NOTICE OF VIOLATION

Violation 1. Energy Safety observed that in implementing 2024 WMP initiative 8.1.2.1.1 - Covered Conductor (SH-1), SCE failed to provide accurate data in reporting covered conductor installation on Pole ID 4381032E, Grid Hardening ID TD1966279-4381032E, at coordinates 34.463617, -119.711308.

INSPECTION REPORT

Item1IA1Img1: No covered conductor observed

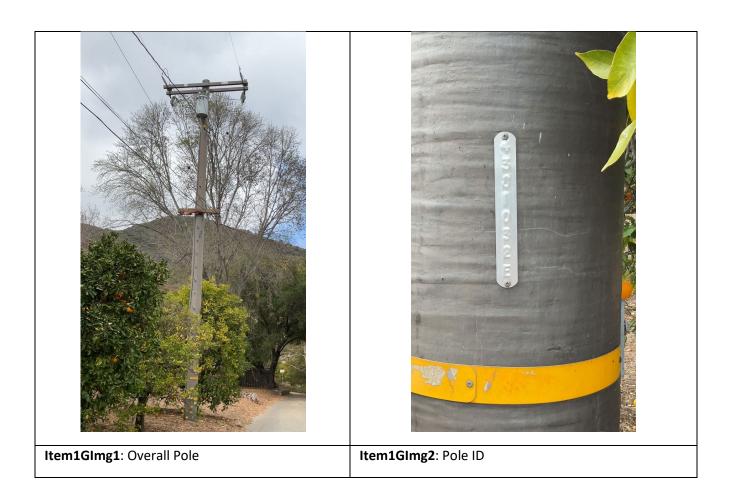
On Pole ID 4381032E, Grid Hardening ID TD1966279-4381032E, at 1450 Tunnel Rd, Santa Barbara, CA, 93105, USA, coordinates 34.463617, -119.711308, the inspector observed that no covered conductor was present. The inspector's observation is documented in Violation 1 photographs, which are attachments to this report. Photo numbers Item1IA1Img1, Item1IA1Img2, Item1IA1Img3, and Item1IA1Img4 depict that no covered conductor was installed at the location. Per the 2024 2nd quarter Quarterly Data Report, SCE indicated that the covered conductor work was completed at this location.
